**From:** Detterman, Mark, Env. Health  
**Sent:** Tuesday, August 20, 2013 12:35 PM  
**To:** 'Sami Malaeb'; britpete@aol.com; reinlib@aol.com; LGRIFFIN@OAKLANDNET.COM; 'mrodarte@waterboards.ca.gov'  
**Cc:** Roe, Dilan, Env. Health  
**Subject:** RO2945; Chevron 9-8861; 2145 35th Ave, Oakland: Soil and Groundwater Investigation; Additional Soil Bores  
**Attachments:** Figure for Proposed Borings.pdf; Attachment A Preferential Pathway and Sensitive Receptor Survey.pdf

### **TECHNICAL REPORT REQUEST**

- **October 25, 2013**– Soil and Groundwater Investigation Report; with Revised Cross Sections; File to be named: RO2945\_SWI\_R\_yyyy-mm-dd

- BH16 through BH22 are already drilled borings ●
- BH23 through BH27 are additional proposed borings ■

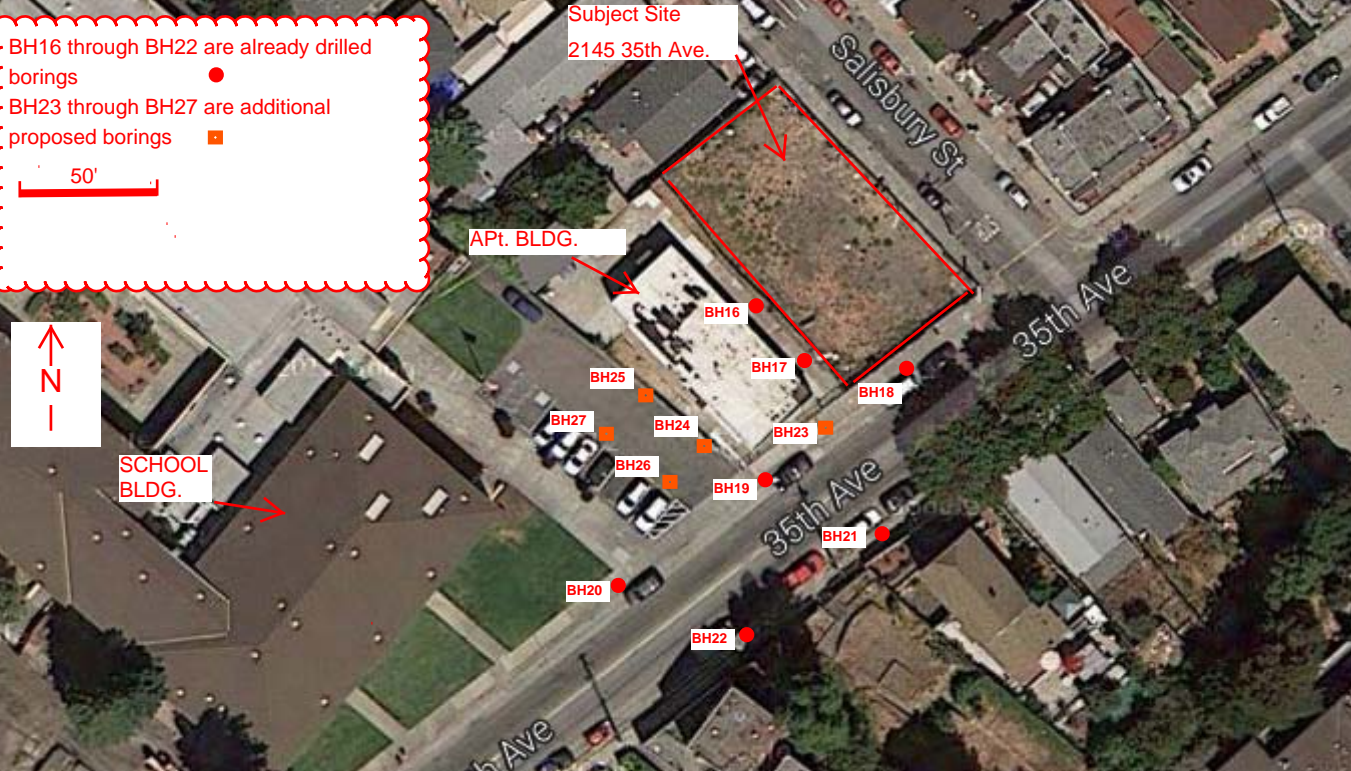
Thanks for the packet of data from the most recent site investigation, including the revised aerial image of existing and proposed soil bore locations (attached). You have indicated that the aerial image provides the best depiction of soil bore locations due to the scale of the figure. As originally intended, after the submittal of the data packet it was anticipated that groundwater monitoring wells would be installed to provide downgradient delineation of the groundwater plume. While the recently installed soil bores detected potentially significant concentrations of TPH immediately offsite (up to 7,100 ug/l TPHg, 5,000 ug/l TPHss, 2,100 ug/l TPHd, and 8 ug/l benzene), they do not appear to have detected the downgradient extent of the groundwater contamination. Because the site is located in a stream valley and the subsurface is very granular, the possibility of natural preferential pathways (paleochannels such as buried stream segments) may be providing a natural conduit away from the site. ACEH is in agreement that it appears more appropriate to redirect site activities and install up to 5 additional soil bores in order to understand natural pathways in the subsurface beneath the site and vicinity. As such two limited soil bore transects have been proposed (infill of a line between BH18 and BH19, and a transect perpendicular to 35<sup>th</sup> Ave - BH19 to BH25). As discussed, due to the potential for these natural conduits, ACEH prefers soil bore transects with a spacing of no more than 20 feet in distance. ACEH understands that the bores in these two transects will be repositioned slightly in order to meet this requested spacing goal. It is understood that bores BH26 and BH27 may be repositioned to meet the spacing goal, or held in reserve in case indications of contamination are encountered in the other transects. Please note that the installation of groundwater monitoring wells has not been eliminated; it may still be appropriate to install wells downgradient of the site presuming an offsite soil or groundwater plume is identified.

While not previously requested it appears that an offsite utility conduit survey will be useful to understanding the potential downgradient extent of groundwater contamination at the site and vicinity. It is understood that approved costs may not include this scope or work. Because the information will likely prove useful, we can discuss when the work is best incorporated into the work flow. Groundwater appears to be located at depths that are coincident with typical utility installation depths and may also provide a manmade preferential pathway away from the site that may account for the apparent lack of an offsite groundwater plume. Thus the utilities should be accounted for in order to understand contaminant flow pathways. As a consequence, ACEH requests that a utility survey (location and depth) of utilities in the vicinity of the site be illustrated in future site plans. Please see Attachment A, Preferential Pathway and Sensitive Receptor Survey, but please be aware that a sensitive receptor survey is currently not requested as an offsite plume has not been documented at this time.
